TYPE 1
FLEXIBLE CONSTRUCTION
(1:20)

Client					
Project Title					
LAND AT WEST END NURSERY ANGMERING					
Status					
SUBJECT TO TECH APPROVAL					
Drawing Title					
SECTION 38/278 CARRIAGEWAY FLEXIBLE SPECIFICATION					
Drawn		Date		Checked	
PJW		07.16		TS	
				Date	
				07.16	
				Approved	
				SW	
				Date	
				07.16	
Scale		Orig Size		Dimensions	
As shown		A3		m	
Project No.				Drawing File	
132485					
Drawing No.				Rev.	
WSCC-S278/38/21				DE

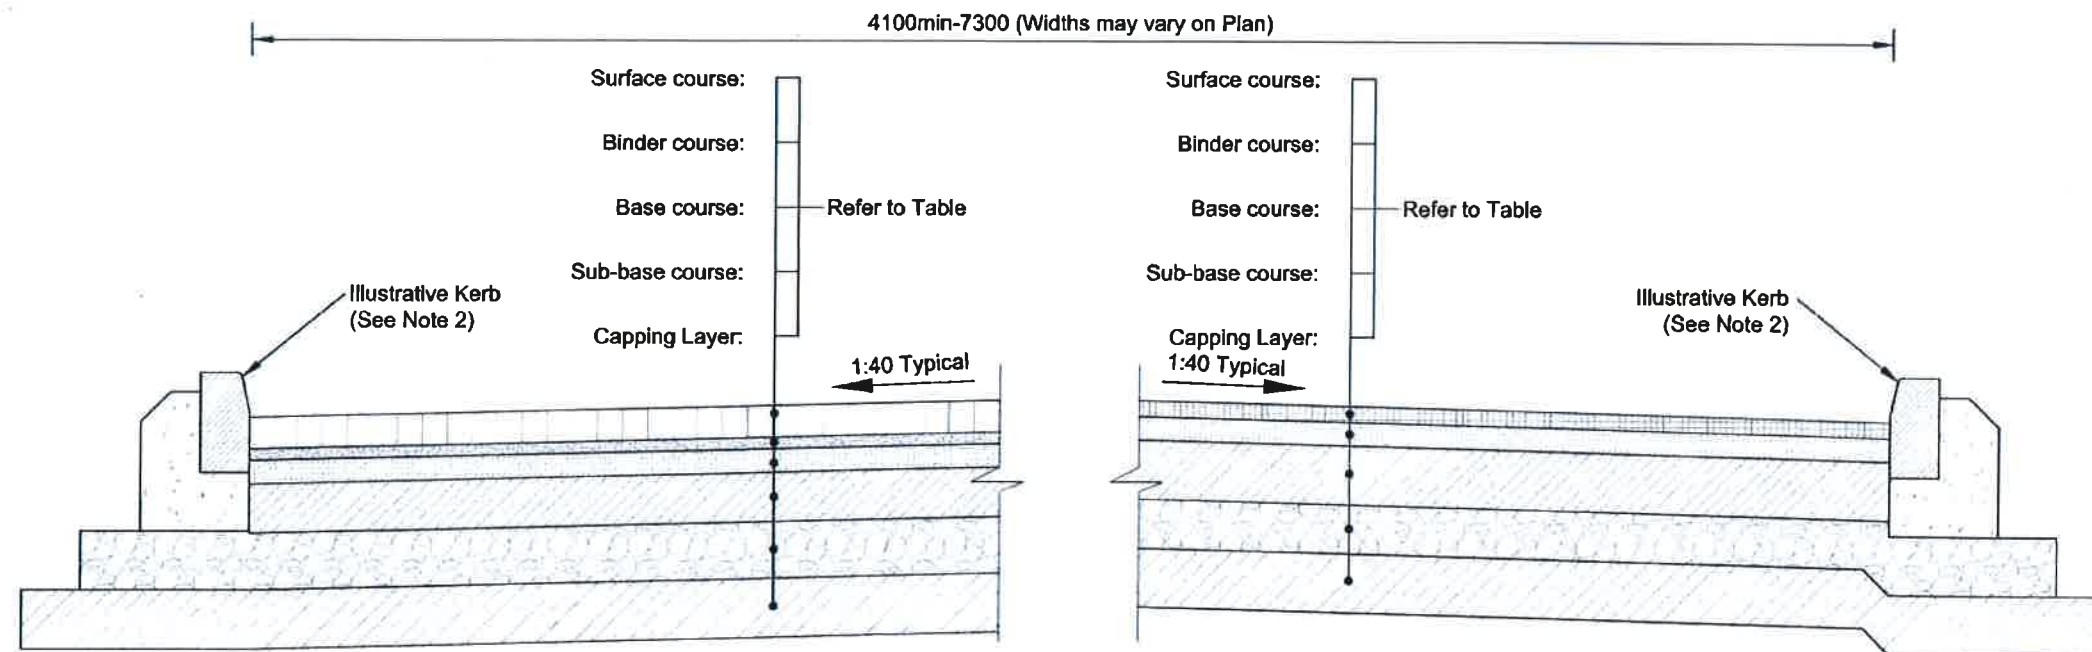
Surface course (Anti - skid)	40mm HRA Bardon superflex 50 with 10mm aggregate (65 PSV)
Binder course	60mm of 20mm Dense Asphalt Concrete - Binder 40-60 PEN
Base course	150mm of 32mm Dense Asphalt Concrete - Binder 40-60 PEN
Sub base	150mm of Type 1 material to clause 803
Capping layer	Bespoke design to IAN 73 / 06 (CBR <2%) 600mm of Type 6F1/6F2 (CBR 2-2.5%) ~~350mm of Type 6F1/6F2 (CBR 2-2.5%)~~ ~~100mm of Type 1 (CBR <2%)~~

E	20/07/16	CAPPING TO SUIT CBR'S	PJW	TS	SW
D	20.07.16	WSCC drawing revised to be site specific	PJW	TS	SW
Rev	Date	Amendment	Drawn	Chkd	Appd.
